Powertrain Management: All Technical Service Bulletins Stalls/Runs Out of Fuel While Gauge Shows Fuel Remaining

Bulletin No.: 67-65-19

Subject:
Vehicle Stall or Runs Out of Fuel While Gauge Shows Fuel Remaining (Repair/Replace Fresh Air Hose/Canister and Bracket)

Models:
1994-95 Buick Roadmaster
1994-95 Cadillac Fleetwood
1994-95 Chevrolet Caprice, Impala SS
with 4.3L, 5.7L Engines (VINs W, P - RPOs L99, LT1)

Figure 1

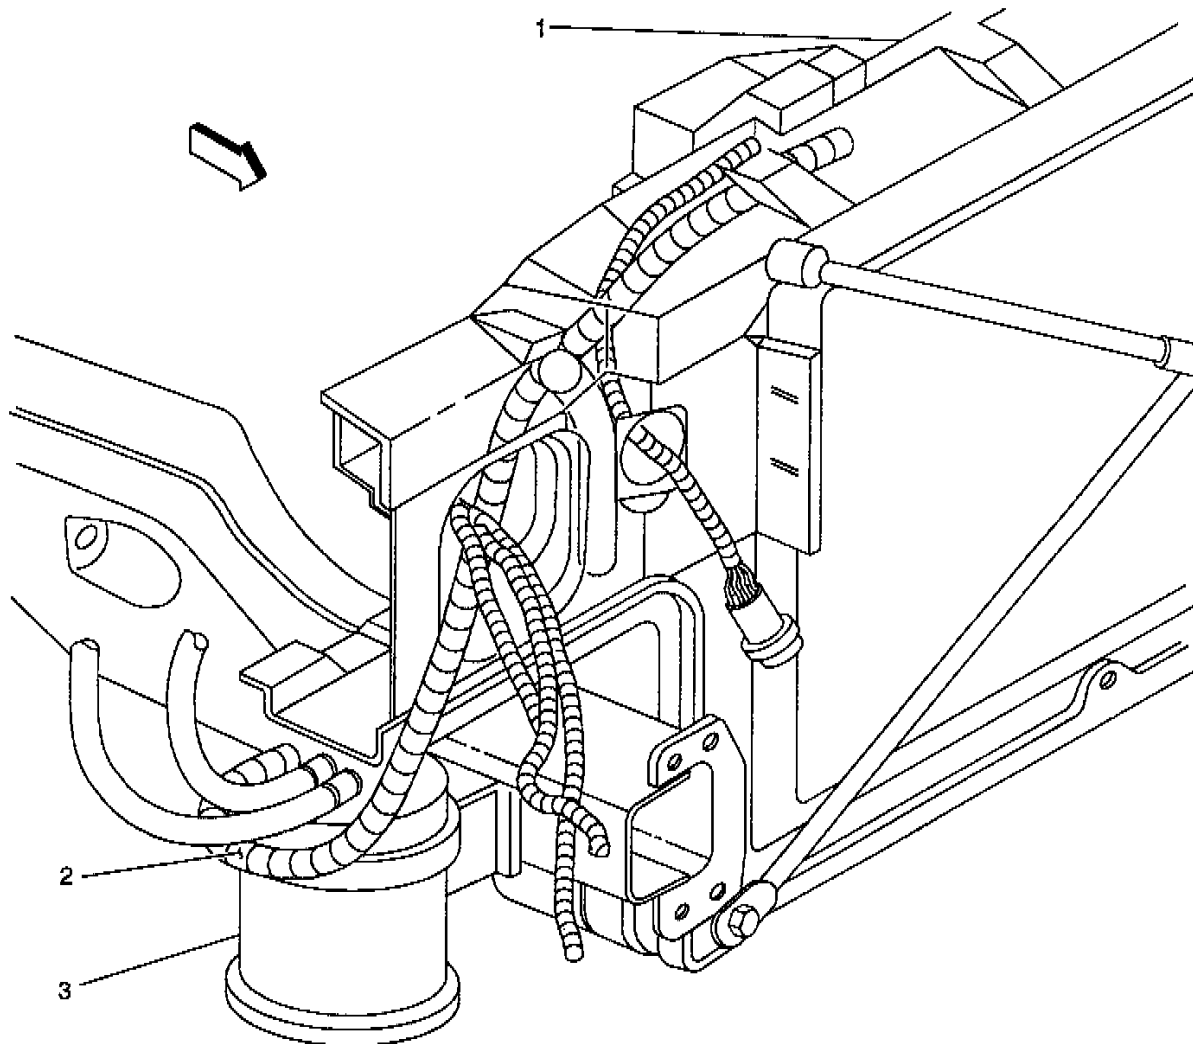
- 5. If the fresh air hose is located in the RH fender well, relocate it to the front radiator support area. See Figure 1.
- 6. If the fresh air hose is not kinked or damaged and there is still a restriction, replace the canister and bracket.
